**SYDNEY CENTRAL CITY PLANNING PANEL
Addendum Assessment Report**

Panel Reference	2017SWC048 DA
DA Number	DA/237/2017
LGA	City of Parramatta Council (formerly Hornsby Shire Council)
Proposed Development	27 storey mixed use tower comprising ground floor retail unit, first floor commercial office unit and 101 shop top housing units above, including 91 parking spaces in 4 basement levels; following demolition of existing buildings. The application is Nominated Integrated development under the Water Management Act 2000.
Street Address	24 - 36 Langston Place, EPPING NSW 2121 (Lot 3 DP9836, Lot 1 DP707822, Lots A & B DP342194)
Applicant	Langston R & J Pty Ltd ABN: 98120139556
Owner	J.R. Hunt Real Estate Pty Ltd, James and Patricia Crether, Langston R & J Pty Ltd
Date of DA lodgement	22 March 2017
Number of Submissions	1 st Advertisement: 12 2 nd Advertisement: 5 (4 resubmissions) Total: 17 (13 unique individuals/organisations)
Recommendation	Deferred Commencement
Regional Development Criteria	The development has a capital investment value of more than \$20 million (criteria at the time of lodgement).

Report prepared by	Alex McDougall
Report date	19 September 2018

Figure 1. Minimum Separation between proposed tower and CBUS Tower 2.

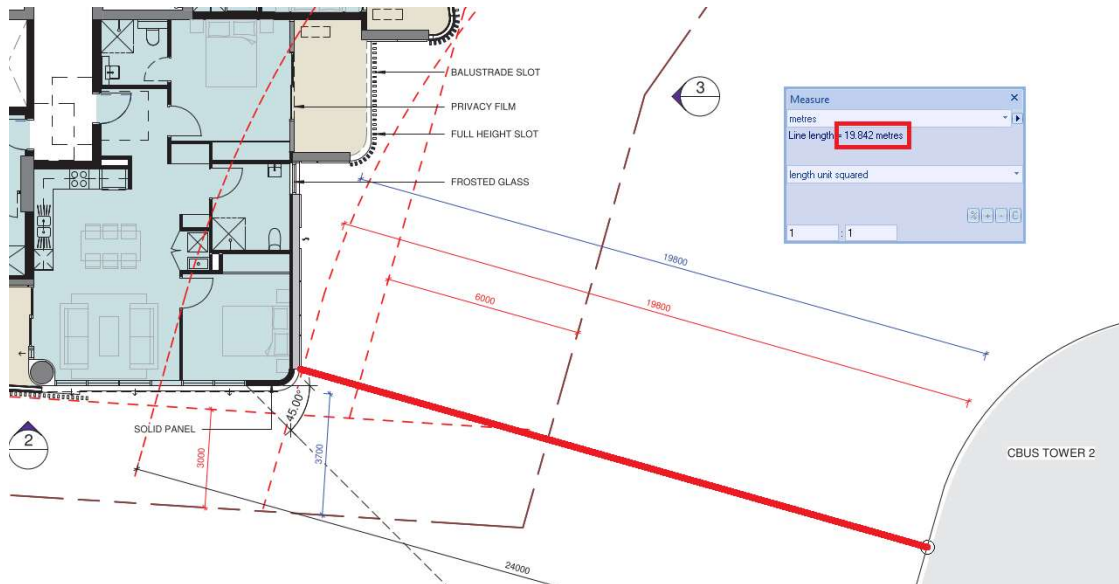
The Panel, upon reviewing the written submission and hearing the oral submission from the adjoining property, appeared concerned with the proposed separation between the proposed building and 'Tower 2' of the adjoining approved development at 12-22 Langston Place.

The ADG requires a separation, at 9 storeys and above of 24m between habitable rooms/balconies.

The proposed habitable rooms and balconies, at their closest, are separated from Tower 2 by 19.8m (See Figure 2 below).

Figure 2. Minimum Separation between CBUS Towers 2 and 3 (19.6 metres).

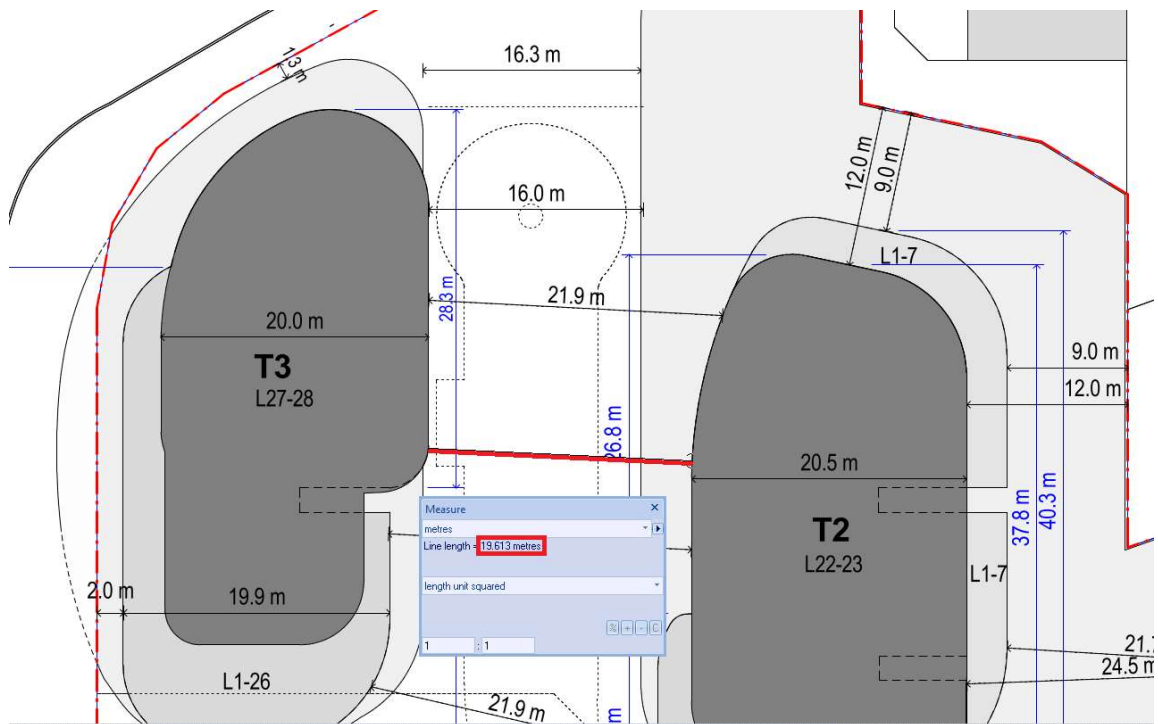
A previous Regional Planning Panel approved a 19.6m separation between Towers 2 and 3 of the approved development at the adjoining site, 12-22 Langston Place (see Figure 2 below). This was in an instance where habitable room windows directly face each other, the two towers are almost parallel and Tower 2 is directly to the north of Tower 3.

As such, there is a precedent which suggests that this can be satisfactory in certain circumstances and is in keeping with the character of the area.

Figure 3. Proposed privacy treatments to protect amenity of adjoining approved tower (inc. previous page).

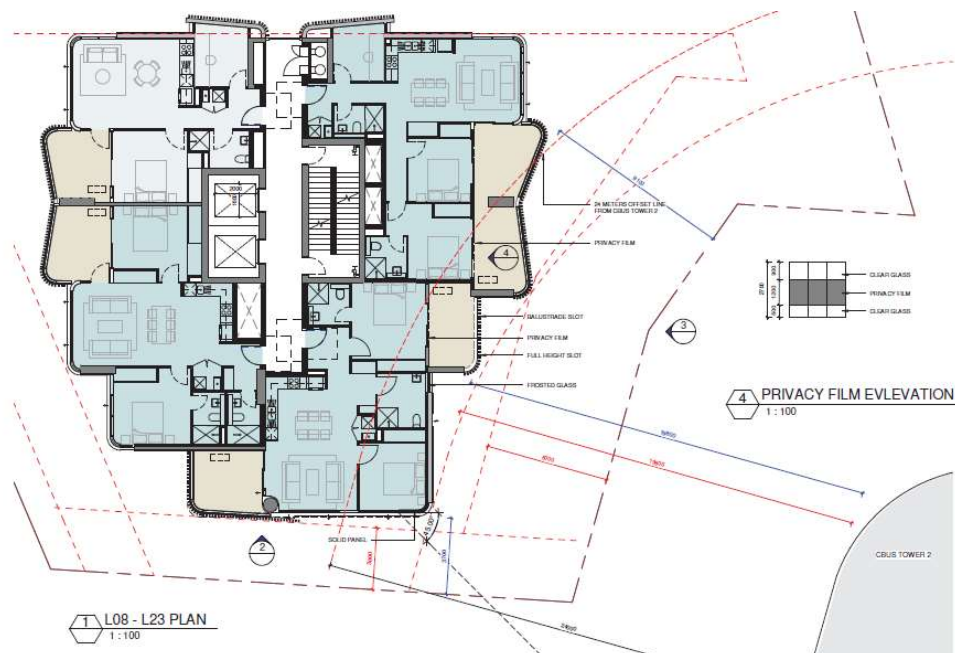
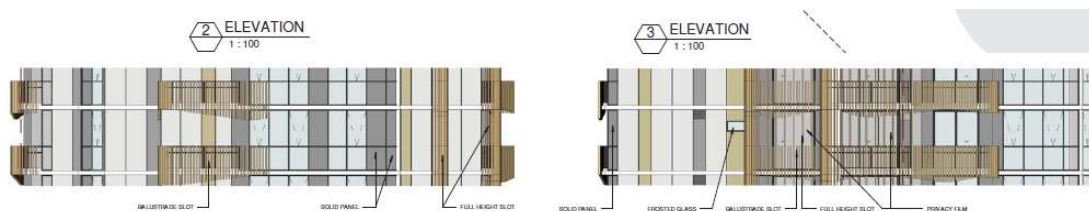
The proposal includes habitable rooms and balconies adjacent to the boundary with the adjoining approved tower and as such the proposal is required to provide a 12m setback to this shared boundary.

The proposed habitable rooms/balconies are located between 6.3m and 12.8m from the shared boundary.

Since the previous hearing, the applicant has added additional privacy measures to the windows and balconies which face, and are within 12m of the shared boundary with, Tower 2. The privacy measures consist of the following:

- Residential layout to provide the primary outlook away from the adjoining approved building.
- Use of opaque/frosted glass on non-habitable rooms windows which face the adjoining approved building.
- Privacy film to bedroom windows.
- Full height and partial height slot treatment to balcony edges to direct the primary outlook away from the adjoining approved building.

Subject to these privacy treatments the proposal is not considered likely to have an unacceptable impact on the privacy of any adjoining/nearby properties.
